**CITY OF FLORENCE  
PLANNING COMMISSION**

**RESOLUTION PC 19 03 DR 01**

A REQUEST FOR A CHANGE OF USE TO SPORTING GOODS STORE WITH OUTDOOR STORAGE AND DISPLAY AREA AT THE SOUTH EAST CORNER OF HWY 101 AND MAPLE STREET

**STAFF REPORT & FINDINGS OF FACT  
FLORENCE COMMUNITY DEVELOPMENT DEPARTMENT  
Planning Commission  
Exhibit "A"**

### SITE PLAN

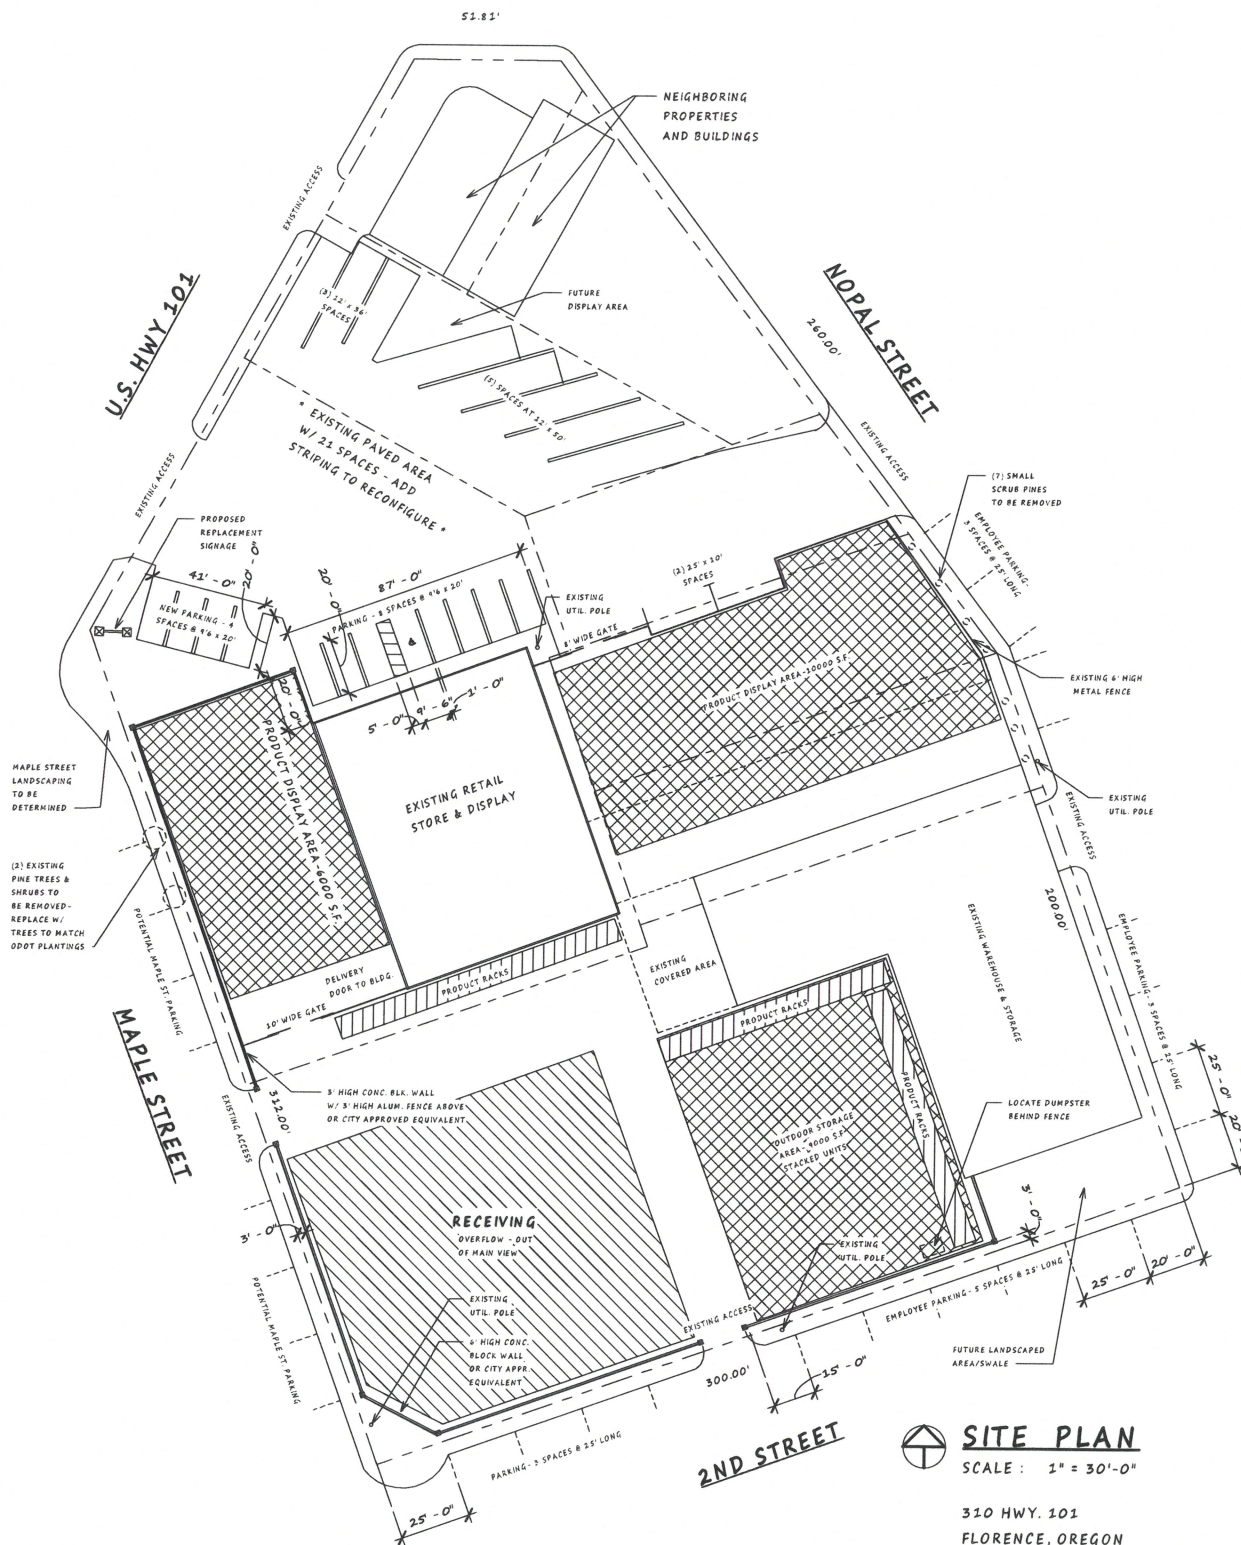
The applicant proposes to change use from “kk. hardware stores, with limited outdoor display” to sporting goods with outdoor storage and display. The site plan illustrates a proposal to locate outdoor storage on either side of the main building that faces Highway 101 in areas presently fenced and storing and display merchandise. Outdoor display areas are proposed within the existing area with an increase of 2,900 sq. ft. of outdoor display area. The display areas are not interpreted to be “limited” but rather the situation is pre-existing and the merchandise is being changed from lumber to ATVs. The ATV sales use is specifically distinguished from automobile sales and repair as the definitions of these include passenger cars and similar state licensed transportation. This sporting goods use could include kayaks and small paddle boats. Automobile, RV, boat, trailer and other similar sales are not included in this review.

The applicant proposes outdoor storage and display and a maintenance shop adjacent to the residences opposite 2<sup>nd</sup> St. and the residence opposite Nopal St. The applicant proposes a 6' masonry wall along 2<sup>nd</sup> St. While this will provide some visual buffering, additional screening is necessary for noise and dust from stocking the gravel storage areas and noise from the maintenance shop. The applicant shall install an evergreen buffer (such as arborvitae) on the inside of the masonry wall along 2<sup>nd</sup> St. and along the Nopal St. building wall of the shop building. **(Condition 9)**

The applicant proposes masonry walls at the driveways on Maple St. and 2<sup>nd</sup> St. The driveways shall provide and maintain appropriate (10') vertical and vision clearance for safe access to and from the site at all times. **(Condition 10)**

3. The applicant shall provide one ADA Van-Accessible parking space meeting all the applicable requirements of FCC 10-3-5 prior to issuance of business license. ADA access aisle shall meet dimension standards and a sign shall be provided.

9. The applicant shall install an evergreen buffer (such as arborvitae) on the inside of the masonry wall along 2<sup>nd</sup> St. and along the Nopal St. building wall of the shop building.

10. The applicant proposes masonry walls at the driveways on Maple St. and 2nd St. The driveways shall provide and maintain appropriate (10') vertical and vision clearance for safe access to and from the site at all times.
